Professional Snagging Inspection Report

Post-completion inspection

Inspection date: 18 July 2026

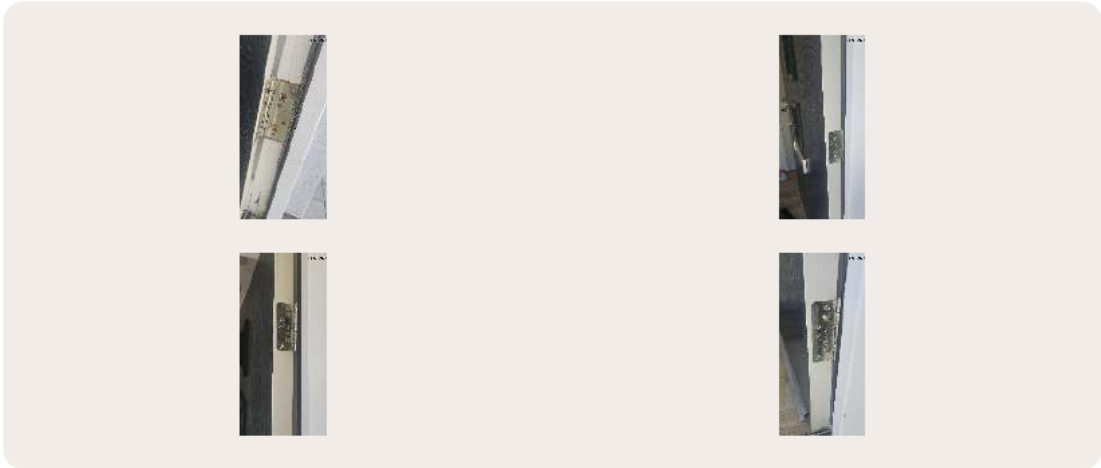
OBSERVATION
Bare timber is exposed behind the front door hinge and has not been sealed or decorated.

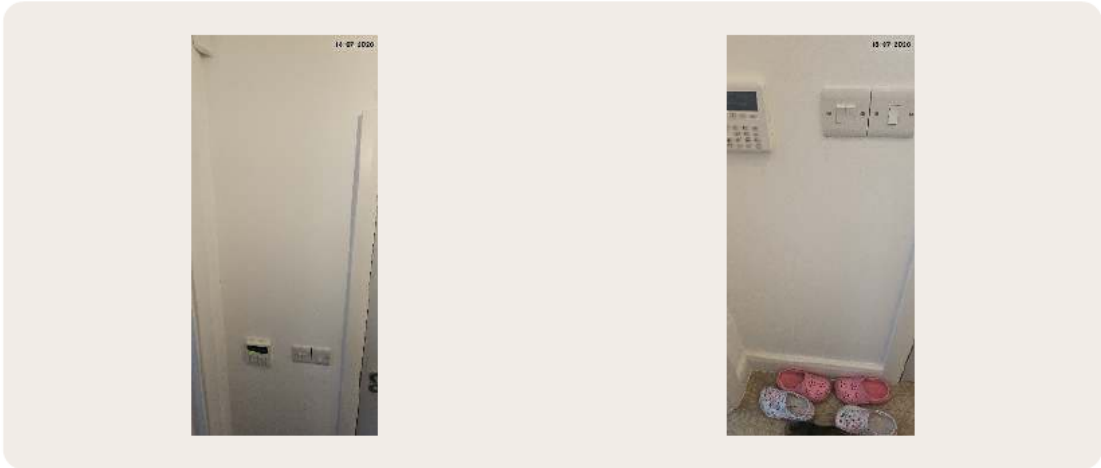
OBSERVATION
Paint coverage is insufficient and the underlying surface is grinning through.

RECOMMENDED ACTION
The plasterer / dryliner should investigate the affected area, remove loose or failed material, correct the alignment or substrate as required, re-tape and apply suitable finishing coats before decoration.

LOCATION	RECOMMENDED TRADE	RISK CATEGORY
Hallway	Decorator	Finish / workmanship

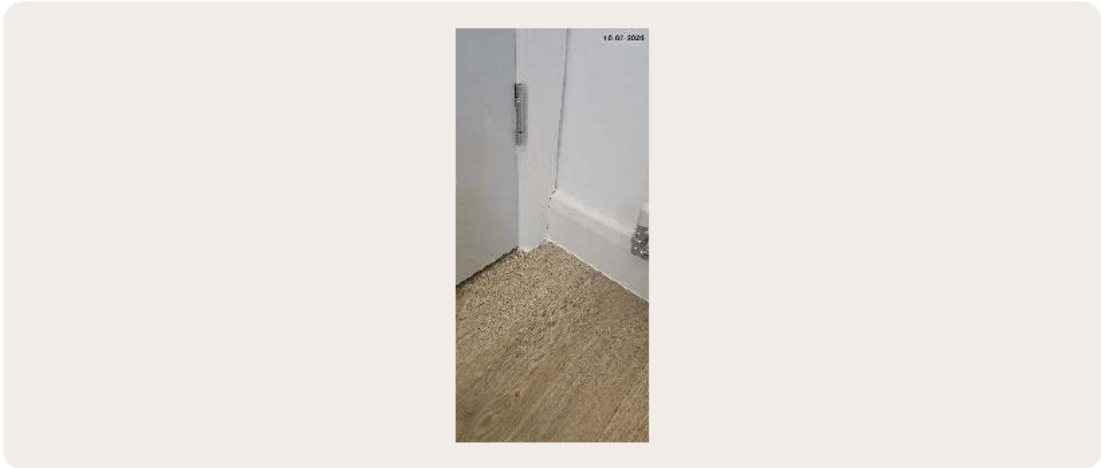
A visible shrinkage gap has opened at the skirting-board junction at recorded location 2 of 4.

Prepare the affected junction, remove loose caulk, apply suitable decorator's caulk, smooth it neatly and redecorate to match the surrounding finish.

LOCATION	RECOMMENDED TRADE	RISK CATEGORY
Hallway	Decorator	Finish / workmanship

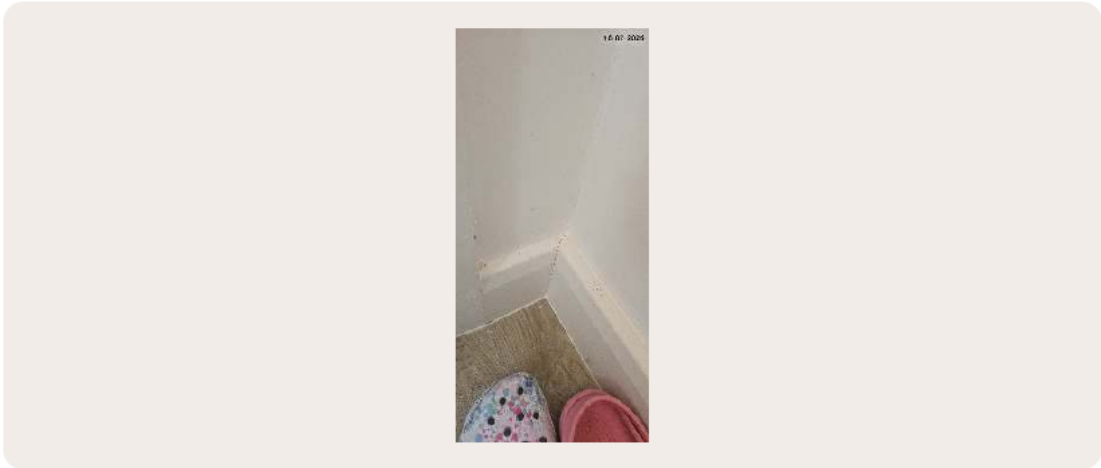
A visible shrinkage gap has opened at the skirting-board junction at recorded location 4 of 4.

Prepare the affected junction, remove loose caulk, apply suitable decorator's caulk, smooth it neatly and redecorate to match the surrounding finish.

LOCATION	RECOMMENDED TRADE	RISK CATEGORY
Hallway	Plumber	Water tightness / services

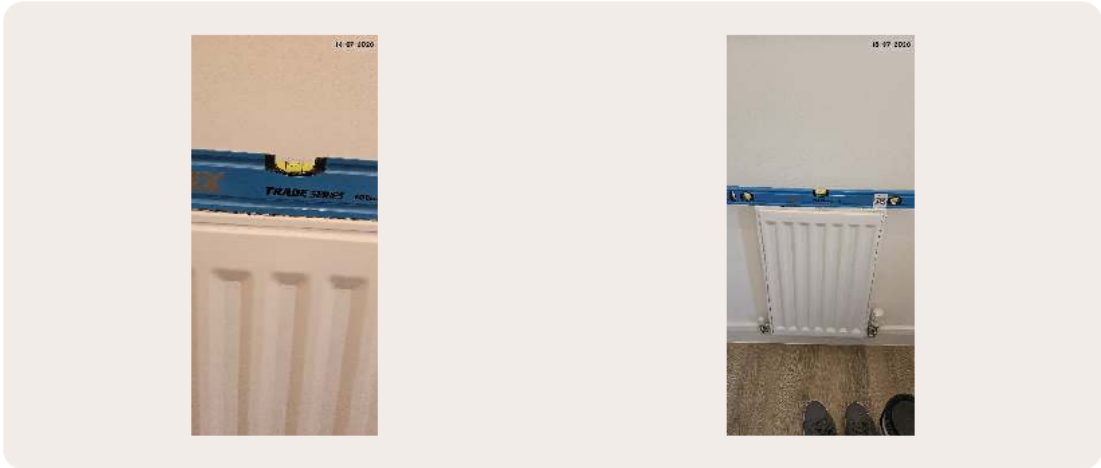
OBSERVATION
The radiator is out of level.

WHY THIS MATTERS
Radiators and associated pipework should be securely installed, level and neatly finished to support safe and effective use.

RECOMMENDED ACTION
Correct the radiator installation, fit the missing radiator pipe guide and seal where applicable, check the connections and make good disturbed finishes.

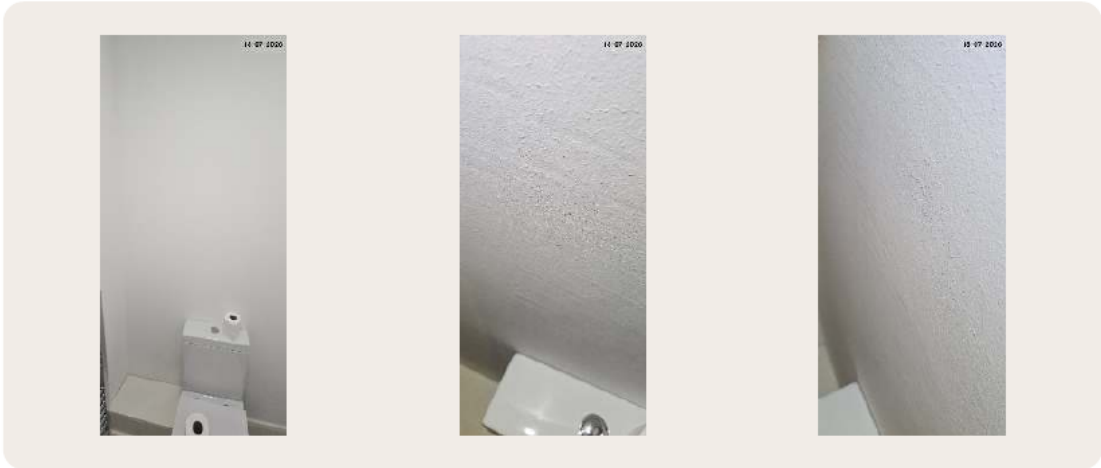
OBSERVATION
Circular jointing or sanding marks remain visible on the wall behind the WC.

LOCATION	RECOMMENDED TRADE	RISK CATEGORY
Cloakroom	Plumber	Water tightness / services

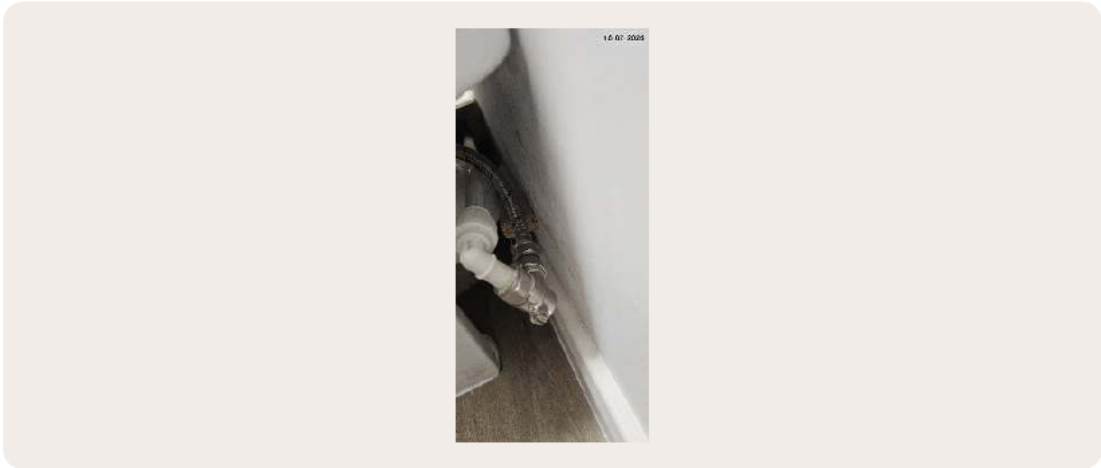
OBSERVATION
The wall finish behind the WC is incomplete, and a timber wedge appears to have been used to support the pan connector.

WHY THIS MATTERS
Sanitary fittings, waste connections and plumbing items should be securely fixed and correctly connected for safe, reliable and watertight use.

RECOMMENDED ACTION
Secure, connect, repair or replace the affected item, then test for stability, correct operation and leaks.

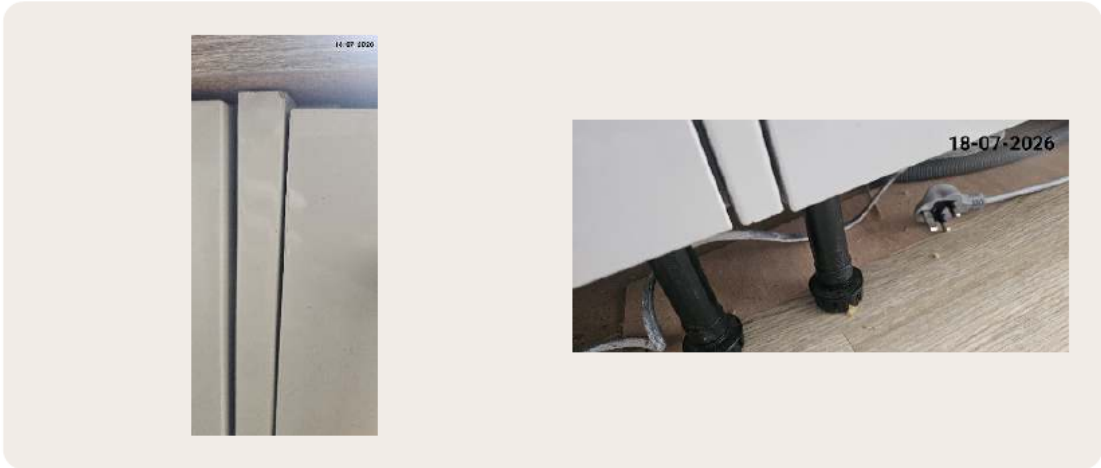
OBSERVATION
The filler panel adjacent to the sink unit is damaged at the top and bottom.

RECOMMENDED ACTION
Adjust, secure, repair or replace the affected item in accordance with the kitchen manufacturer requirements, then confirm correct alignment and operation.

LOCATION	RECOMMENDED TRADE	RISK CATEGORY
Kitchen units	Kitchen fitter	Finish / operation

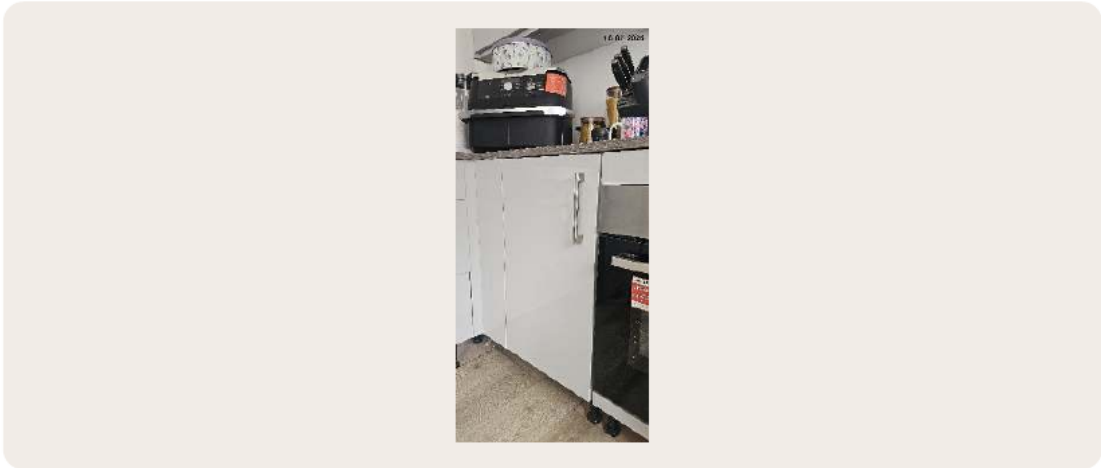
OBSERVATION
A kitchen unit door is misaligned.

WHY THIS MATTERS
Kitchen units, panels, doors, drawers and integrated appliances should be securely installed, aligned and suitable for normal use without damaging adjacent finishes.

RECOMMENDED ACTION
Adjust, secure, repair or replace the affected item in accordance with the kitchen manufacturer requirements, then confirm correct alignment and operation.

LOCATION	RECOMMENDED TRADE	RISK CATEGORY
Kitchen	Kitchen fitter	Finish / operation

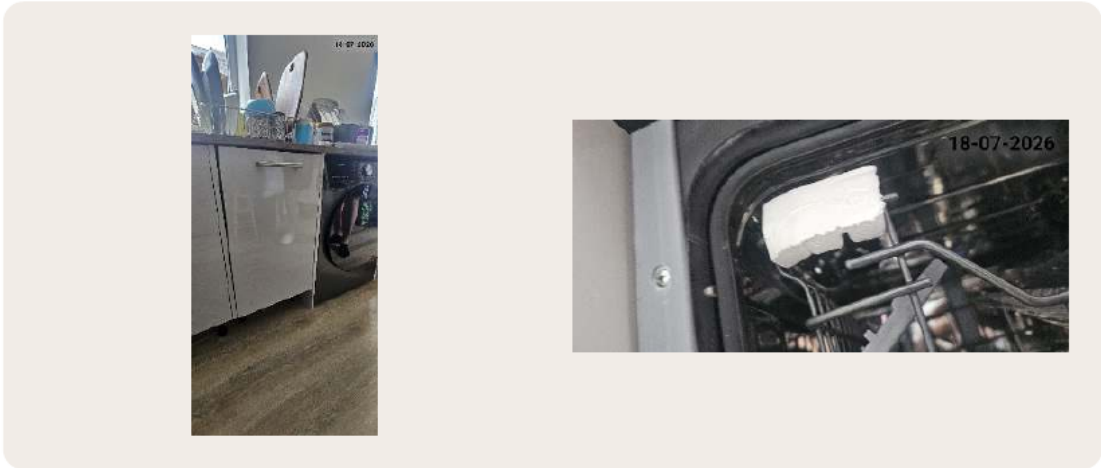
The dishwasher is not securely fixed.

Adjust, secure, repair or replace the affected item in accordance with the kitchen manufacturer requirements, then confirm correct alignment and operation.

LOCATION	RECOMMENDED TRADE	RISK CATEGORY
Kitchen	Plumber	Water tightness / services

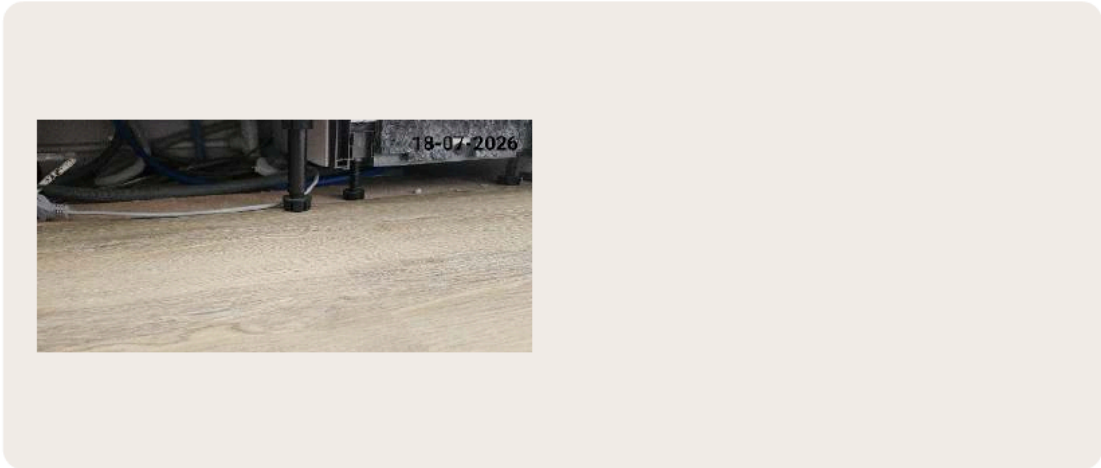
OBSERVATION
The dishwasher has not been connected to the plumbing.

WHY THIS MATTERS
Sanitary fittings, waste connections and plumbing items should be securely fixed and correctly connected for safe, reliable and watertight use.

RECOMMENDED ACTION
Secure, connect, repair or replace the affected item, then test for stability, correct operation and leaks.

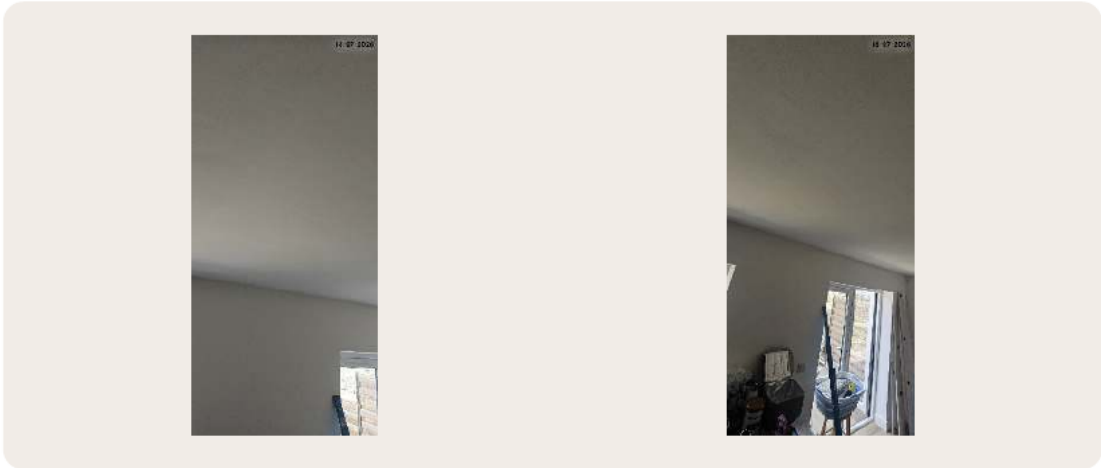
OBSERVATION
The kitchen ceiling board joints remain visible through the finished surface.

LOCATION	RECOMMENDED TRADE	RISK CATEGORY
Kitchen	Decorator	Finish / workmanship

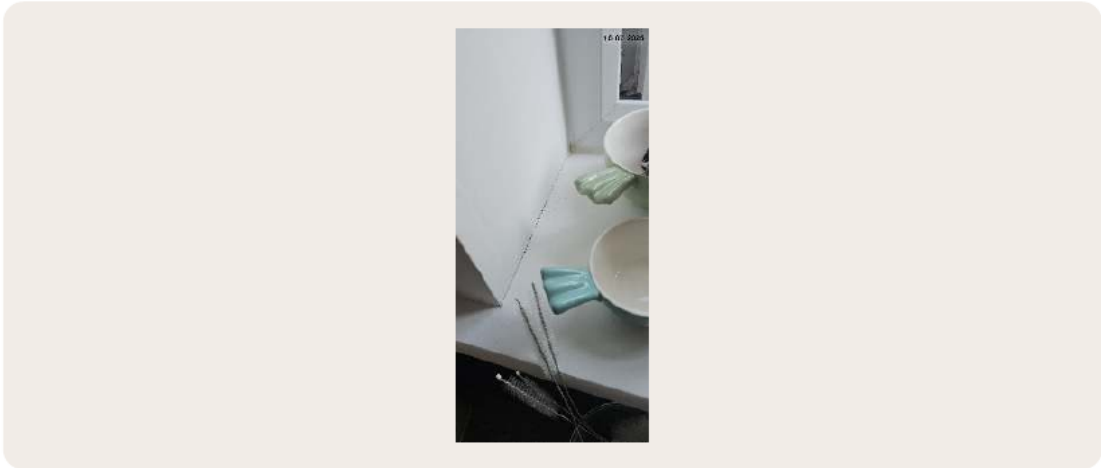
OBSERVATION
A visible shrinkage gap has opened around the kitchen window junction at recorded location 1 of 2.

WHY THIS MATTERS
Visible decorative finishes should be complete, smooth and consistent at handover. Shrinkage, exposed fixings, marks, insufficient paint coverage and incomplete preparation reduce the quality of finish.

RECOMMENDED ACTION
Prepare the affected junction, remove loose caulk, apply suitable decorator's caulk, smooth it neatly and redecorate to match the surrounding finish.

LOCATION	RECOMMENDED TRADE	RISK CATEGORY
Kitchen	Decorator	Finish / workmanship

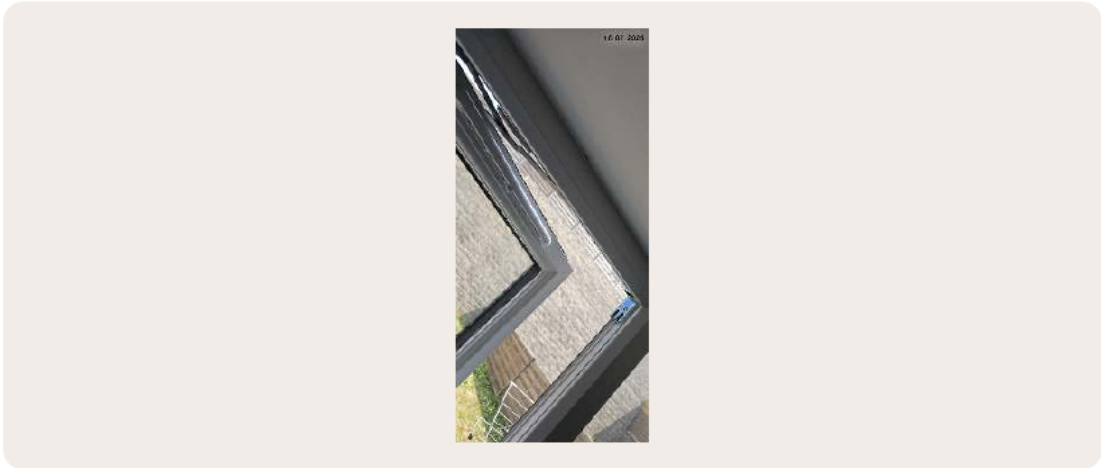
OBSERVATION
A visible shrinkage gap has opened around the kitchen window junction at recorded location 2 of 2.

WHY THIS MATTERS
Visible decorative finishes should be complete, smooth and consistent at handover. Shrinkage, exposed fixings, marks, insufficient paint coverage and incomplete preparation reduce the quality of finish.

RECOMMENDED ACTION
Prepare the affected junction, remove loose caulk, apply suitable decorator's caulk, smooth it neatly and redecorate to match the surrounding finish.

LOCATION	RECOMMENDED TRADE	RISK CATEGORY
Kitchen	Mastic applicator	Weather tightness / durability

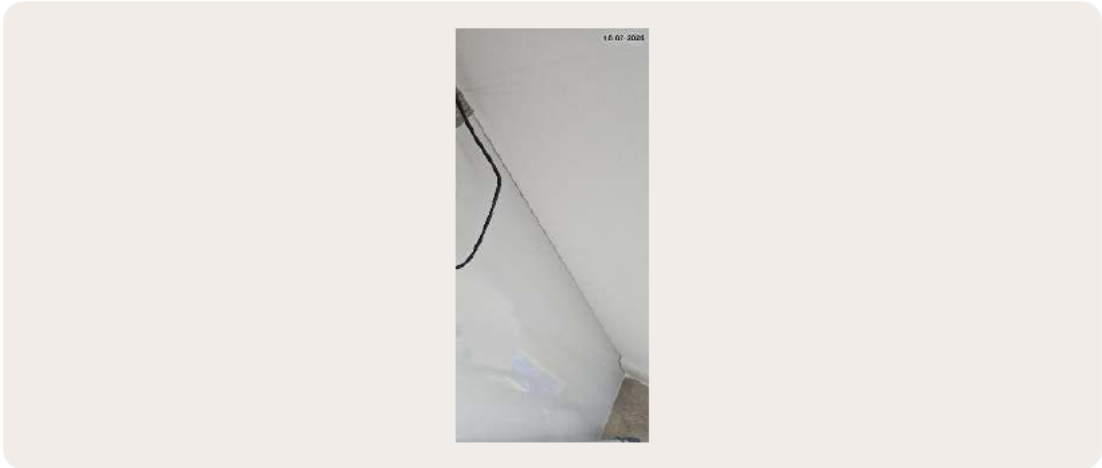
The kitchen end panel has not been sealed to the wall.

Remove unsuitable or incomplete material, clean and prepare the joint, then apply a compatible sealant to form a neat, continuous and durable weather seal.

LOCATION	RECOMMENDED TRADE	RISK CATEGORY
Lounge	Groundworker	Finish / workmanship

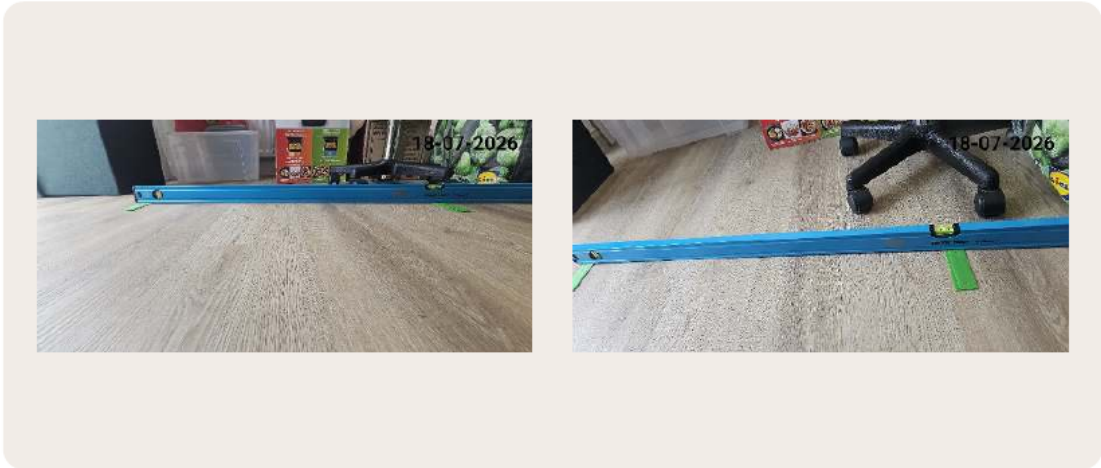
OBSERVATION
There is excessive deviation in the lounge floor levels.

WHY THIS MATTERS
Floors, paving, drainage features and access routes should be stable, reasonably level and suitable for normal use.

LOCATION	RECOMMENDED TRADE	RISK CATEGORY
Kitchen	Plasterer / dryliner	Finish / operation

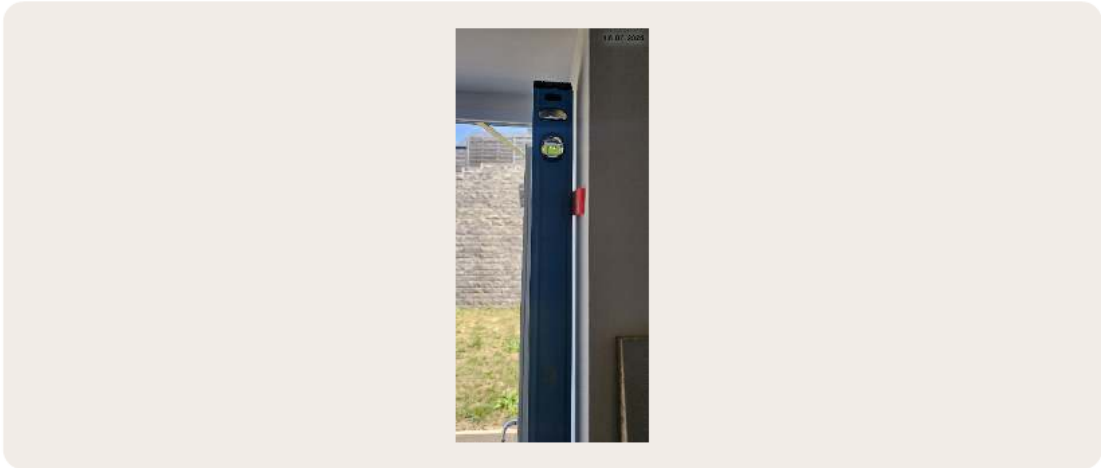
OBSERVATION
The right-hand door reveal is 6mm out of plumb.

RECOMMENDED ACTION
The plasterer / dryliner should investigate the affected area, remove loose or failed material, correct the alignment or substrate as required, re-tape and apply suitable finishing coats before decoration.

LOCATION	RECOMMENDED TRADE	RISK CATEGORY
Stairs	Plasterer / dryliner	Finish / workmanship

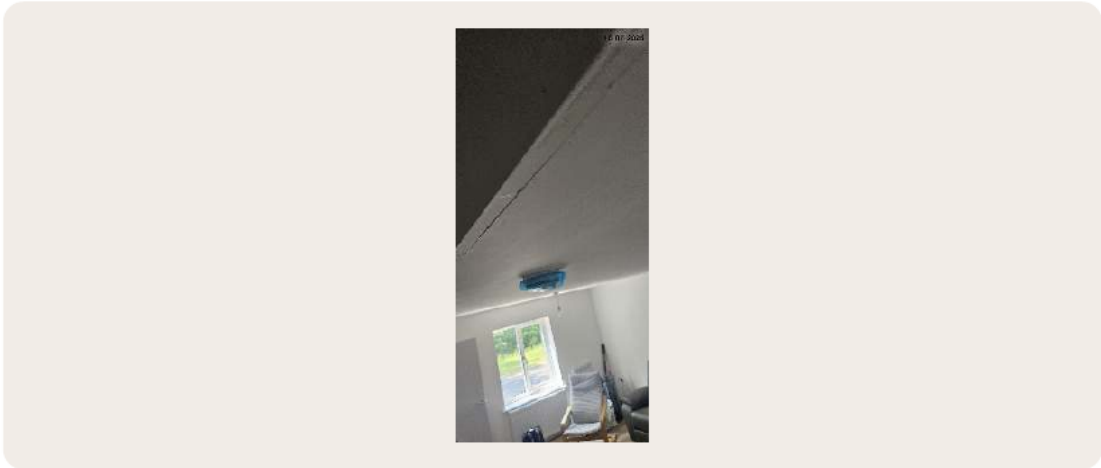
OBSERVATION
The external corner tape has debonded and is visibly raised from the finished surface.

RECOMMENDED ACTION
Remove the failed corner tape, reform the corner with suitable jointing materials, apply finishing coats and redecorate after drying.

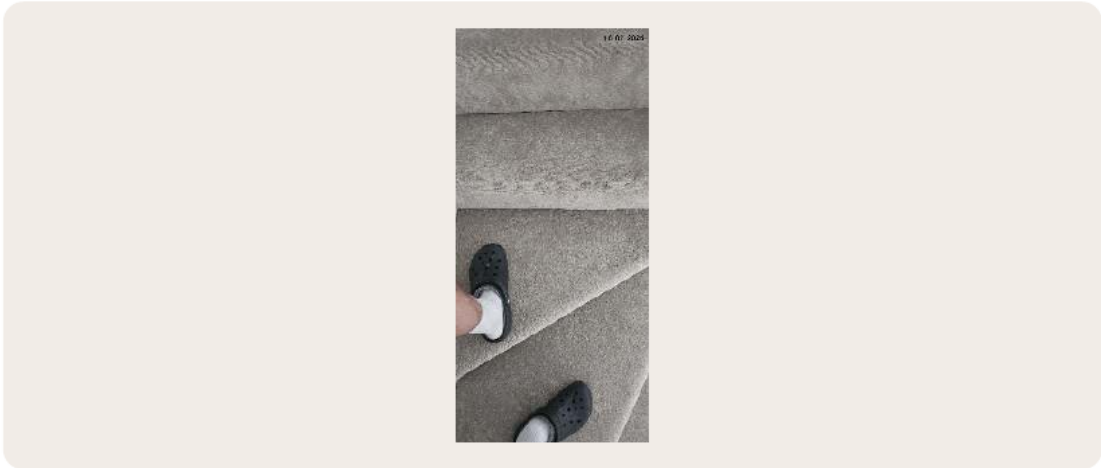
OBSERVATION
A stair winder creaks under normal use.
